Item H-6

Consider a resolution approving a Site Plan with variances for an existing approximately 1,260 square foot structure on 0.17 acres located on the south side of Taylor Street, approximately 85 feet southeast from the Taylor Street and South Main Street intersection, legally described as Lot 2A, Block 11 of Keller, City Addition, zoned Old Town Keller (OTK) and addressed 110 Taylor Street. David Simmons, Owner. Cary Stillwell, Applicant.(SP-23-0030)

Elevations

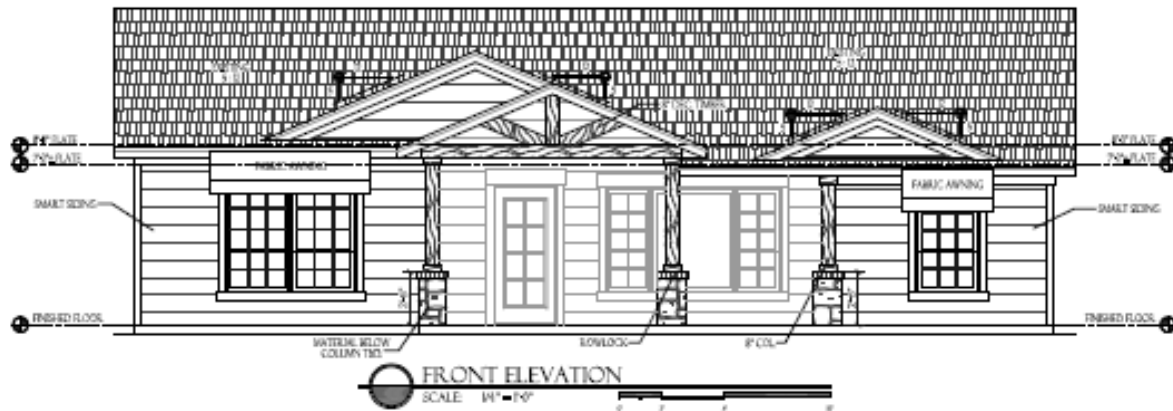
- The Applicant proposes Smart Siding for all elevations and to expand the existing porch with cedar posts and an ADA-compliant ramp.

Elevations

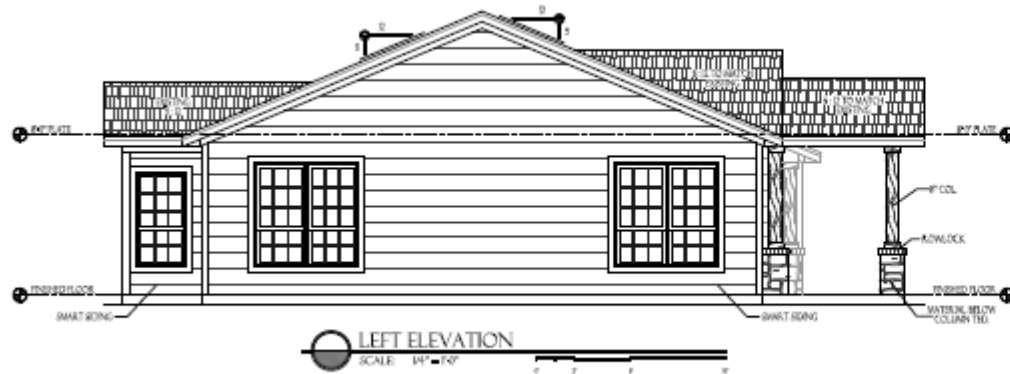
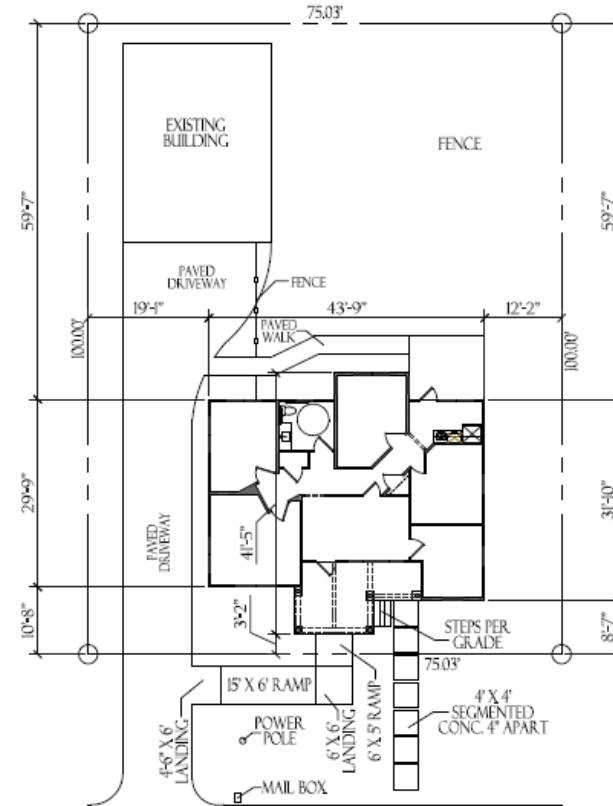
- The Applicant intends to add a concrete walkway from the porch to the street.
- The existing detached garage is wood on a concrete slab.

Parking: Variance Requested

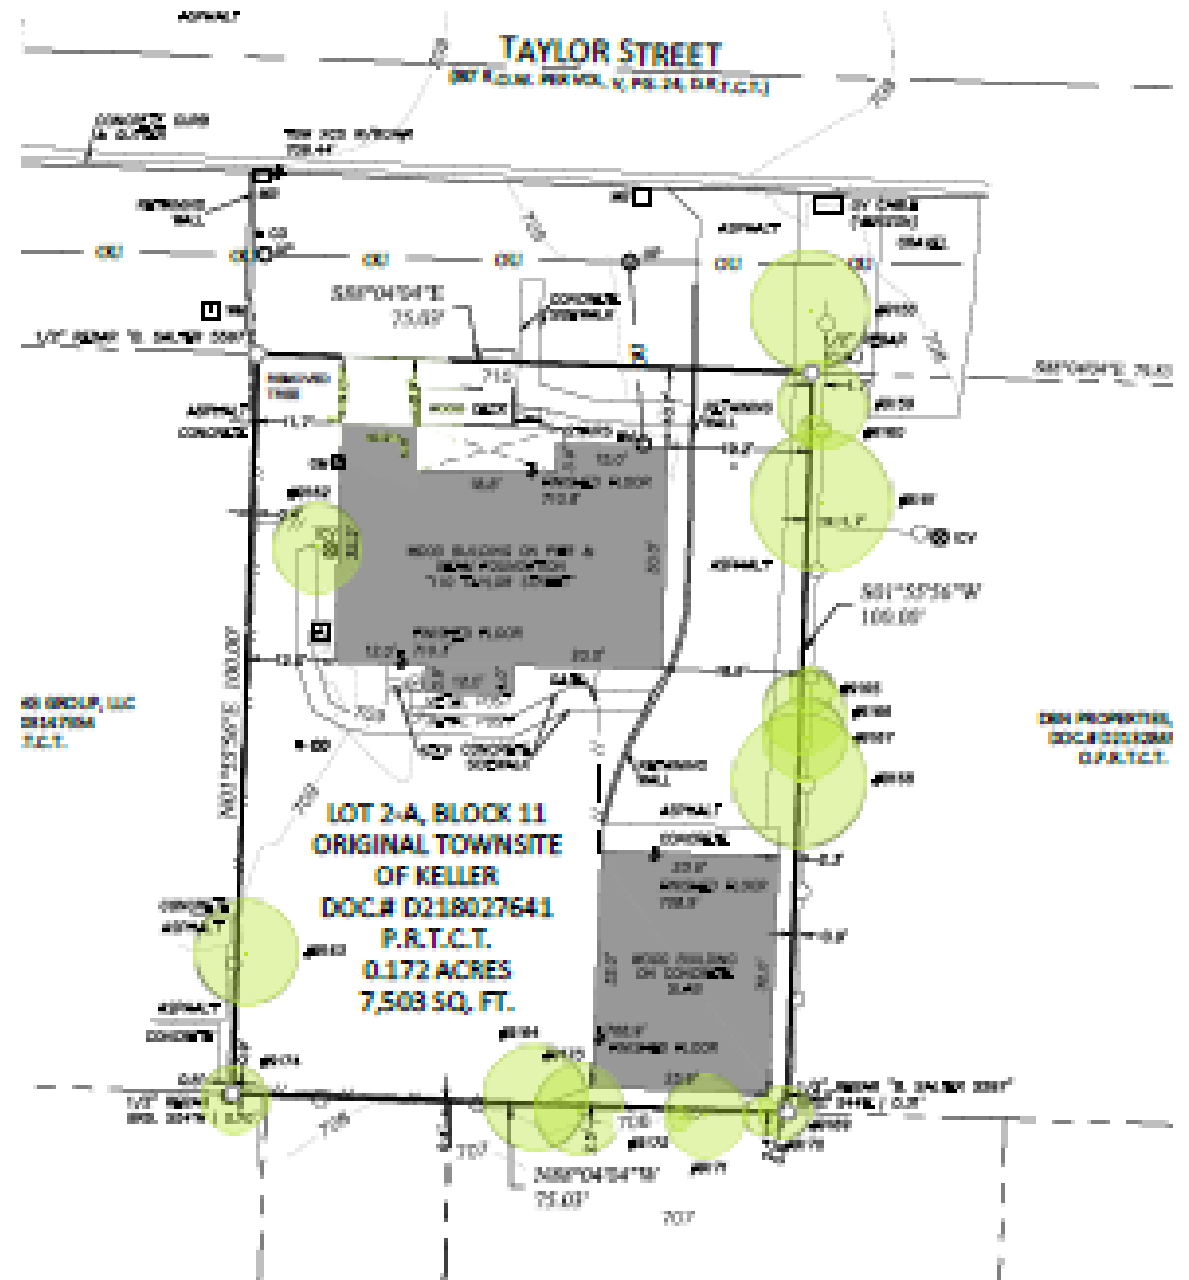
The total parking requirement for a 1,260-square-foot office is 4 spaces plus 1 accessible space.

The UDC parking requirements for the OTK Neighborhood Subdistrict state that “As existing structures in the Neighborhood Subdistrict are redeveloped, the developer or property owner shall be responsible for constructing the ninety-degree (90°) head in parking within the right-of-way composed of either concrete or asphalt.”

2. The Applicant requests a variance to construct no parking as part of this project.
